Amendment C387 ggee to the Greater Geelong Planning Scheme

Landscape Architecture Evidence

Figure 4.2 - Slope analysis by SMEC (based on civil design embodied in Water Technology SWMS, Version 6, 6 September 2023.)

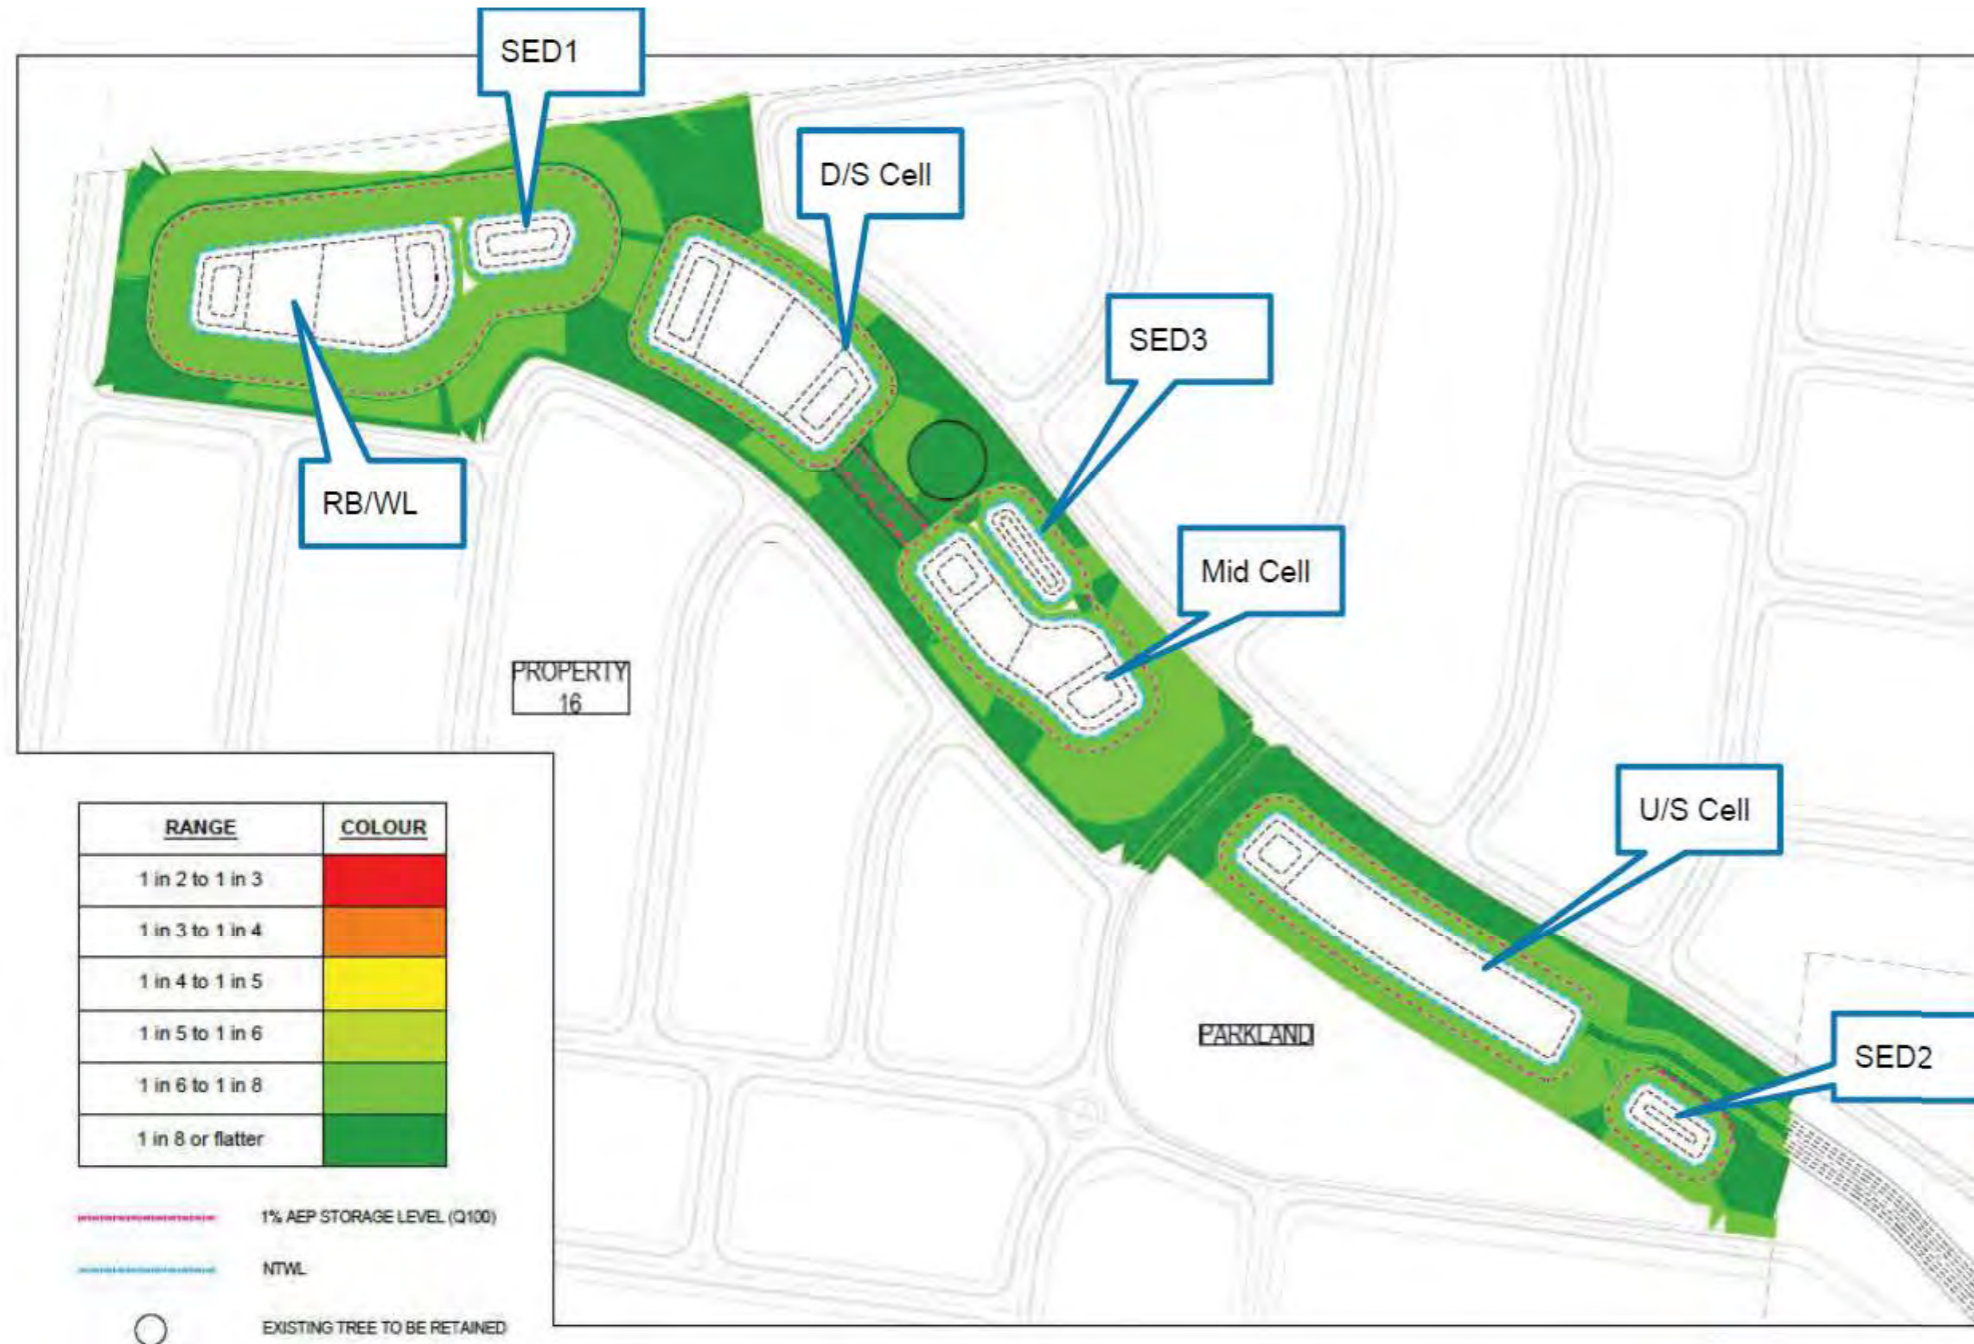
23. These landscape proposals were predicated on there being no batter slopes steeper than 1:6, as shown in SMEC's slope analysis in Figure 4.2. This approach, which I am instructed was driven by discussions with Council, resulted in a land requirement of some 4.2 ha for the drainageway within Property No. 16. As can be seen in Figure 4.1, the landscape approach was essentially to:

24. It is worth noting that in my view, the extent of land-take for this version is inadequate to accommodate all the elements that would in reality be required in the final landscape design. The "*Draft Landscape Master Plan, Rev 0*" is insufficient in that:

- it does not allow sufficient verge space from back of kerb to the shared path given there are 13.5m edge road reserves along the southern edge of the waterway and at the eastern end of the drainageway; and

- it does not have sufficient land for a 1.5m pedestrian path and verge width along the northern side of the drainageway.

My assessment is that these two elements would create a requirement for an additional 0.14 ha of land in the SMEC version of the landscape master plan.

Figure 4.8 - Revised Wetland/Waterway landscape concept - Sections (MDG Landscape Architects, 05.04.2024)

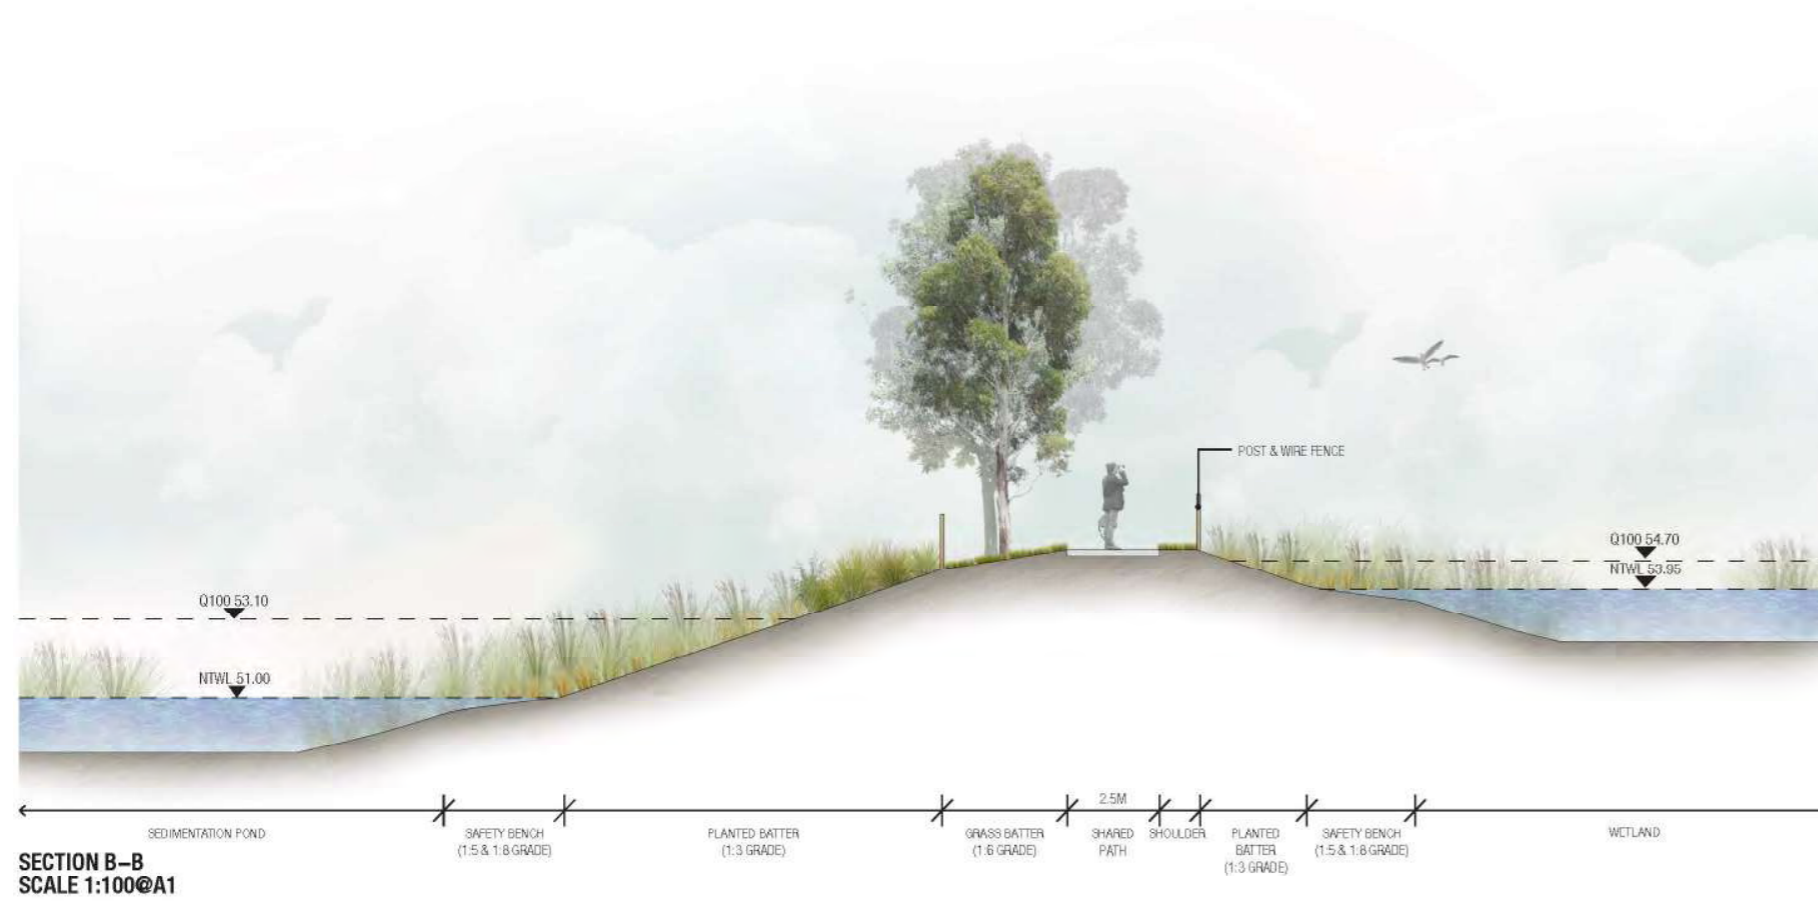
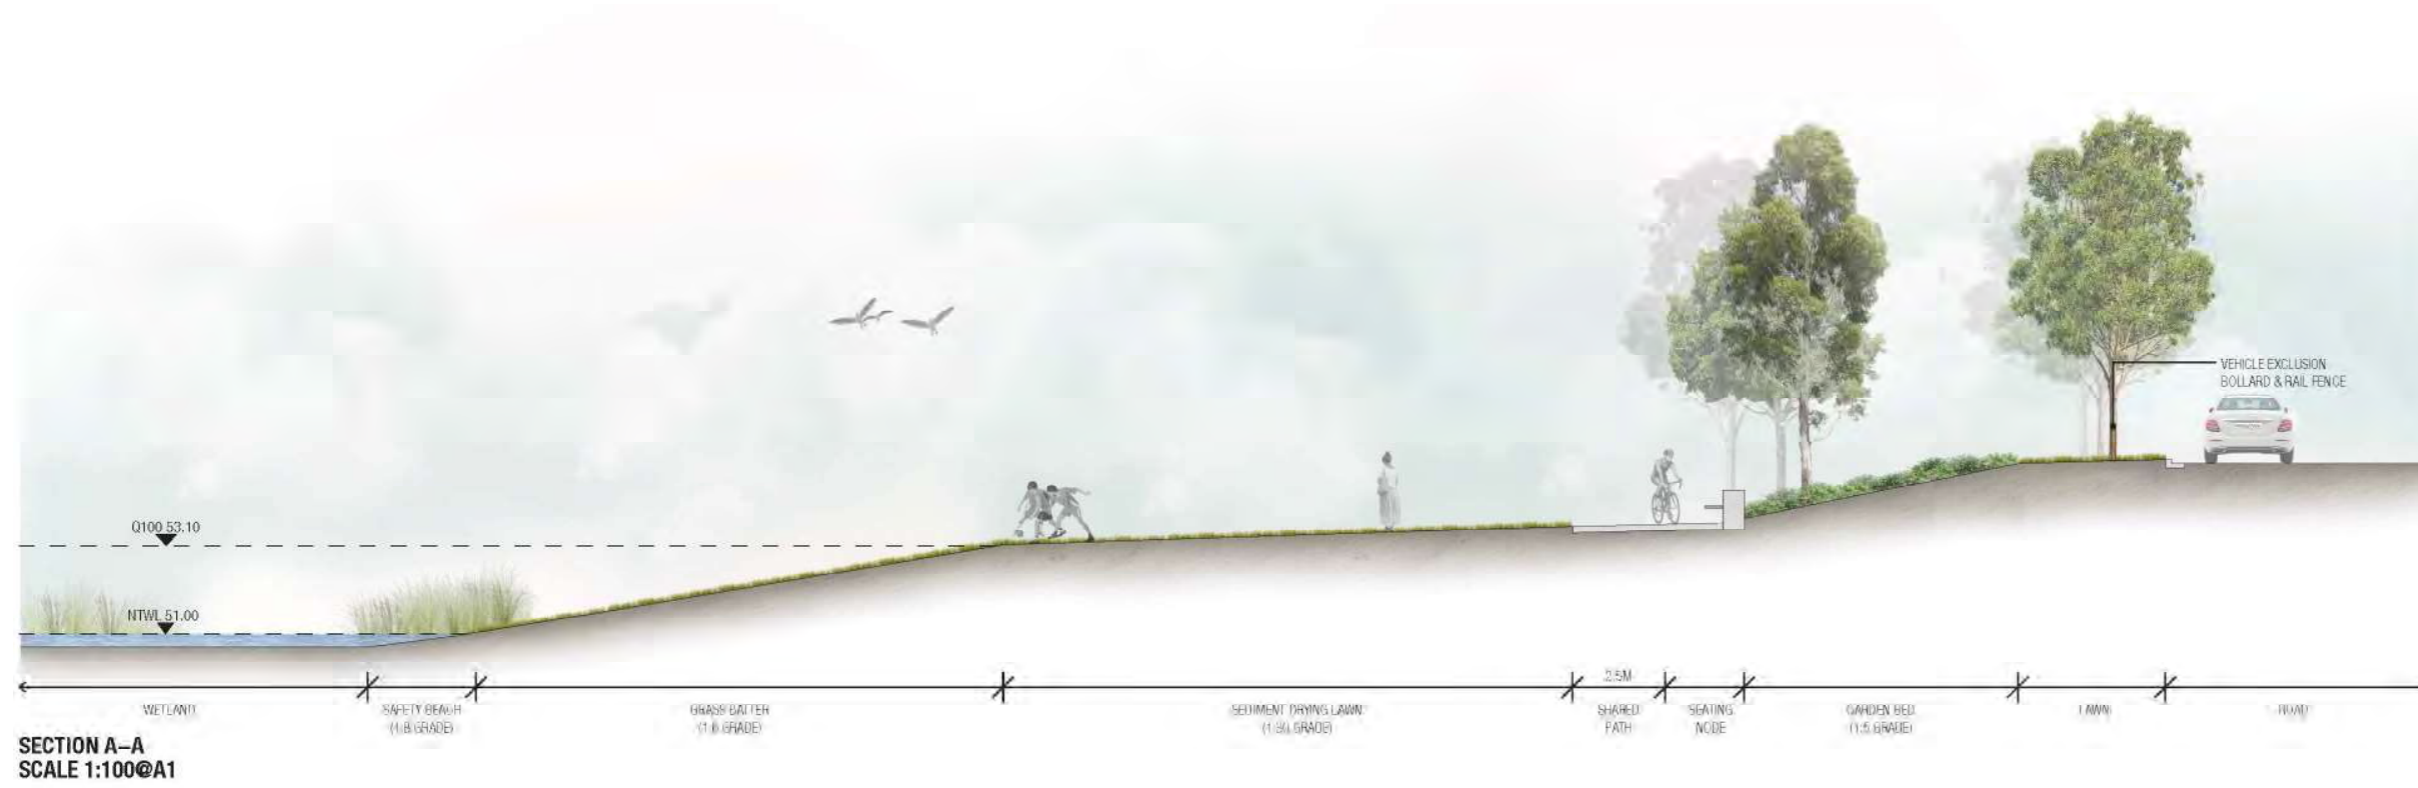
45. The revised design proposes grass for all areas 1:6 or flatter and vegetation for areas steeper than 1:6. This is depicted in the colour-coded version of the landscape concept plan in Figure 4.7. This plan shows that the extent of batters steeper than 1:6 is fairly limited and is concentrated in the central portion of the site.

46. The sections shown in Figures 4.8 – 4.10 give an indication of the extent of the batter slopes meeting the above design criteria. They show the incorporation of limited sections of 1:3 vegetated batters to reduce the width of the overall drainage way. No batters shown in these sections are steeper than 1:3 and therefore are vegetated batters (as opposed to rock batters that would be required under the criteria above for batters steeper than 1:3.) As can be seen in the colour coded plan in Figure 4.7, there is only one area of rock stabilised batter steeper than 1:3, namely just north-west of the local park space.

Figure 5.3 - Extract of Stockland's FLP drawing, with inset showing Road A cross section dimensions

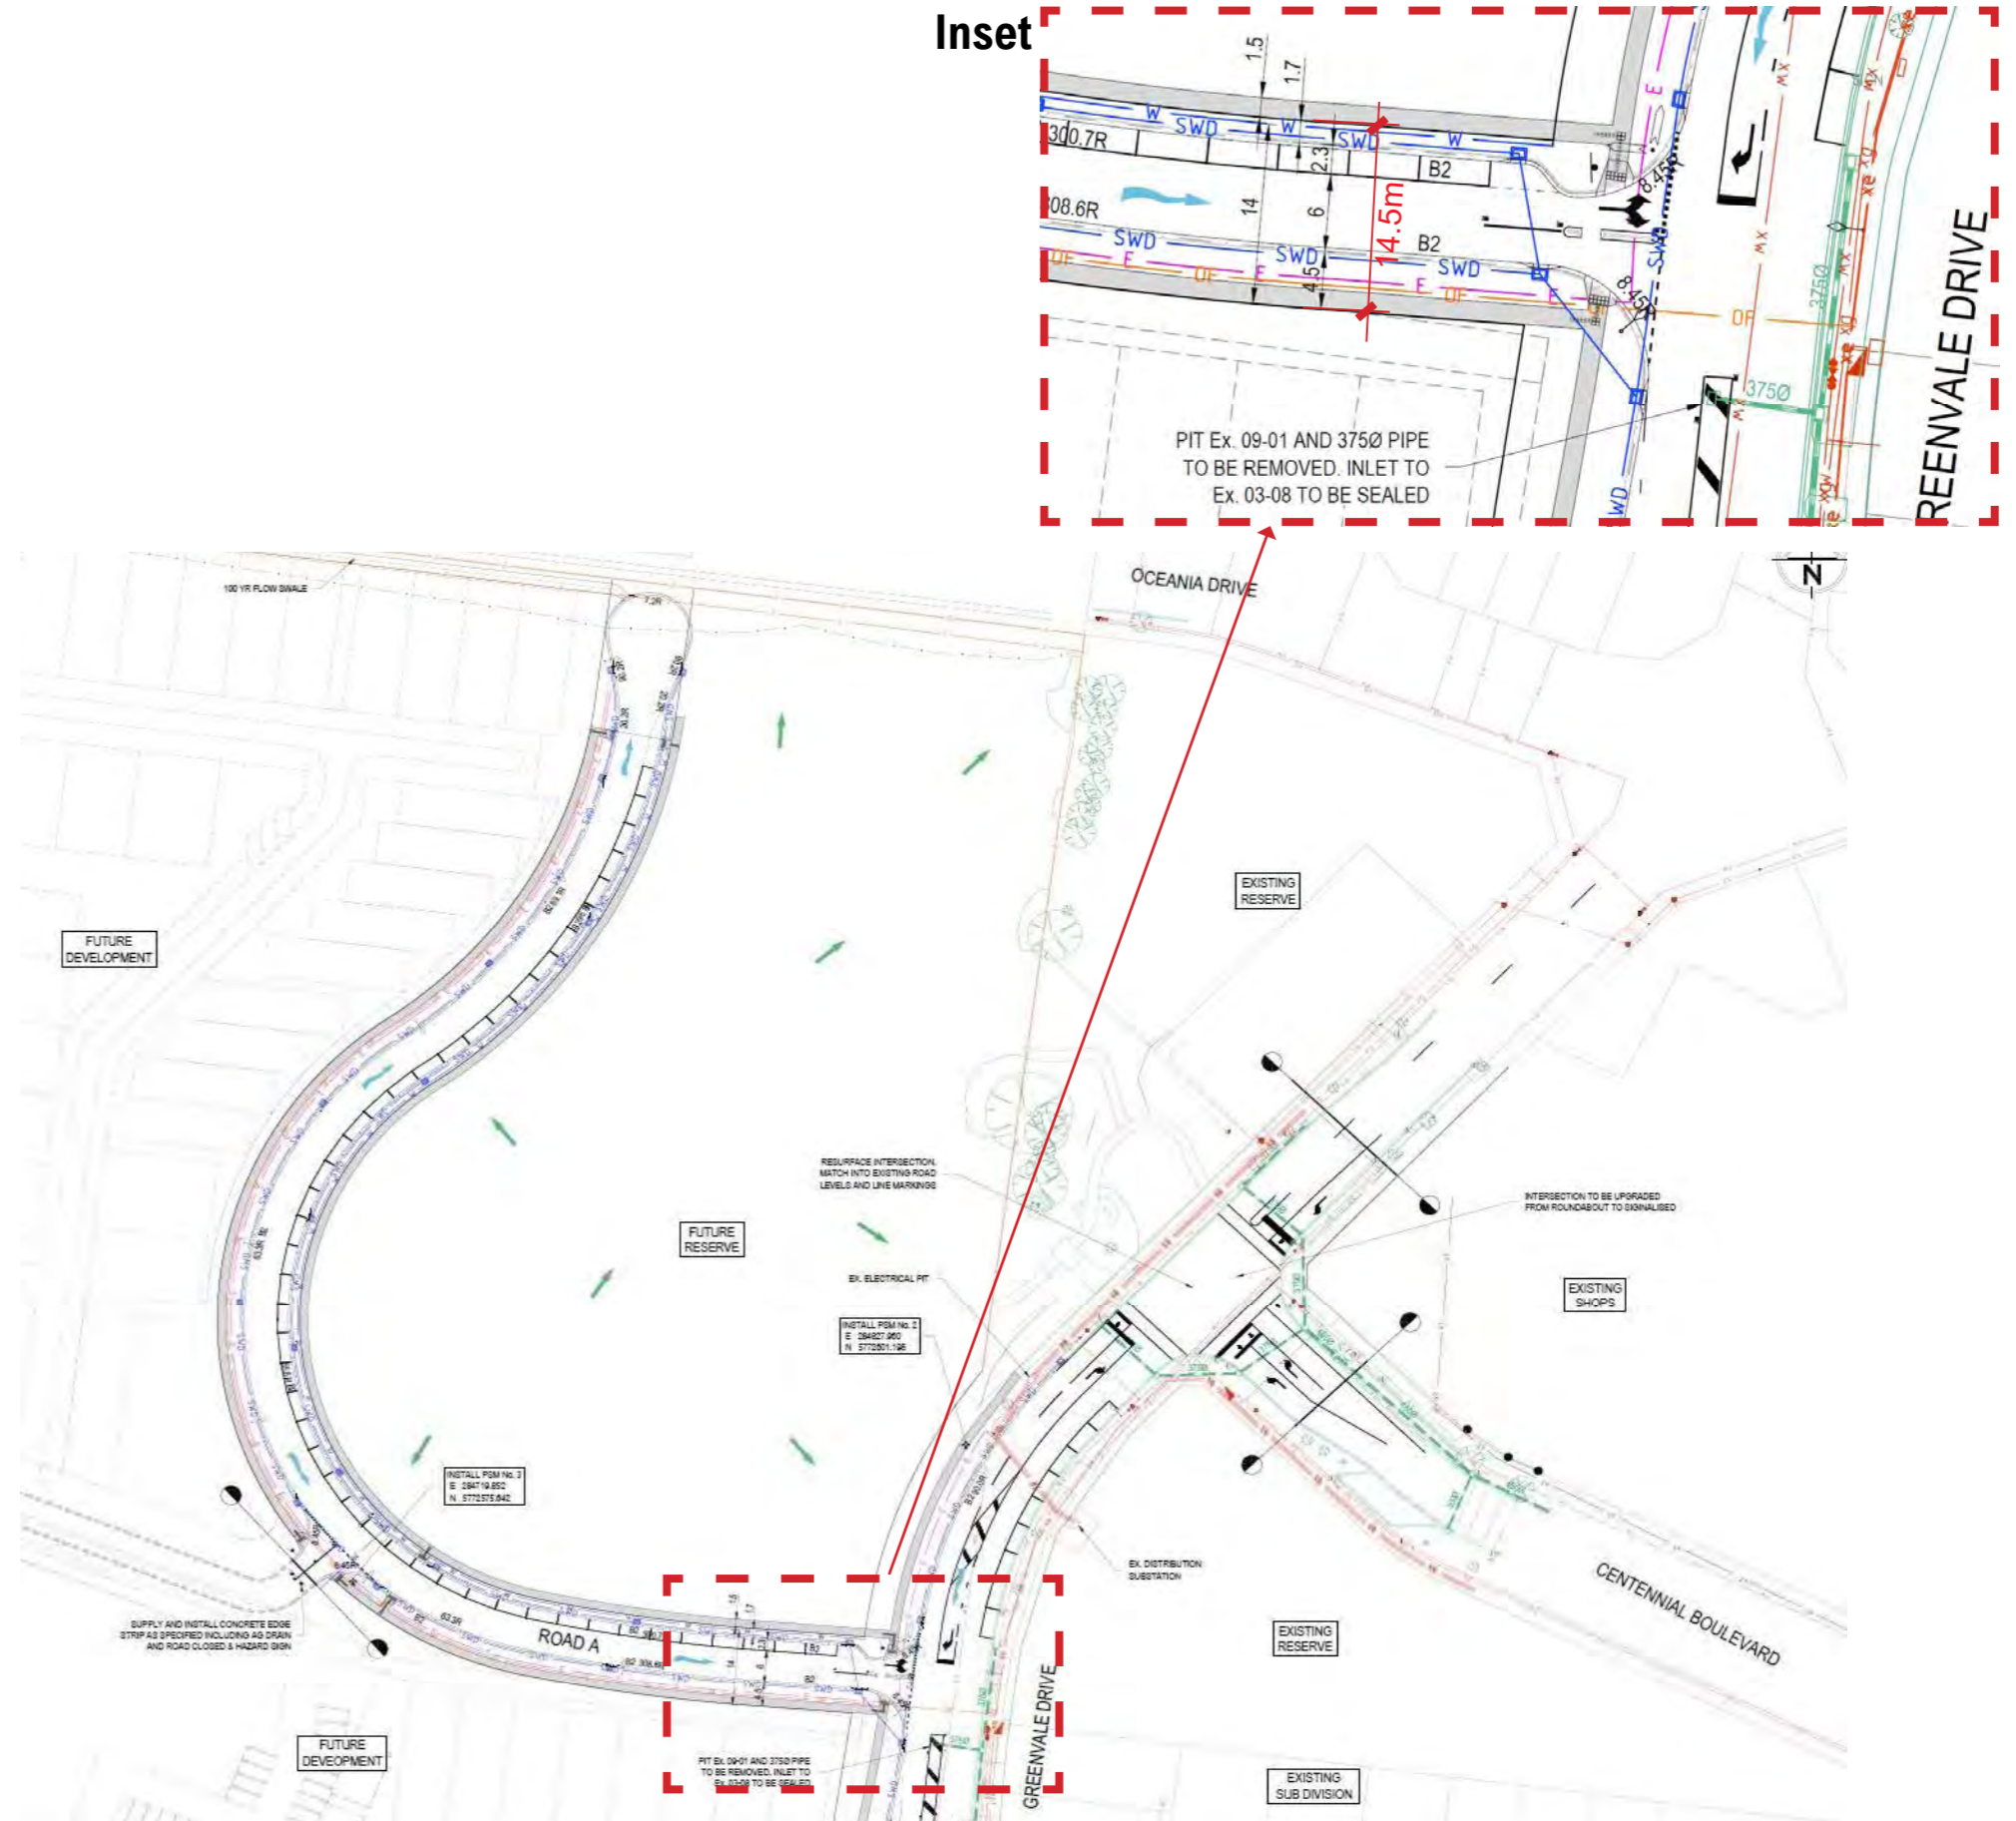
79. The Concept Plan prepared by Stockland indicates a public street as the interface with the park. Stockland's *External Roads Functional Layout Plans* show a 14.5m road reserve that contains a 1.5m footpath on the residential village side, a 3m verge, 6m through pavement, 2.3m indented parking bays and a 1.7m verge on the district park side. (Refer Figure 5.4.) A further 1.5m wide footpath would sit inside the boundary of the district park. (I note that there is a conflict between the plan view and the cross section in the Functional Layout Plans whereby the plan view indicates a 14.5m road reserve and the section indicates a 14m reserve. I recommend the 14.5m road reserve be adopted.)
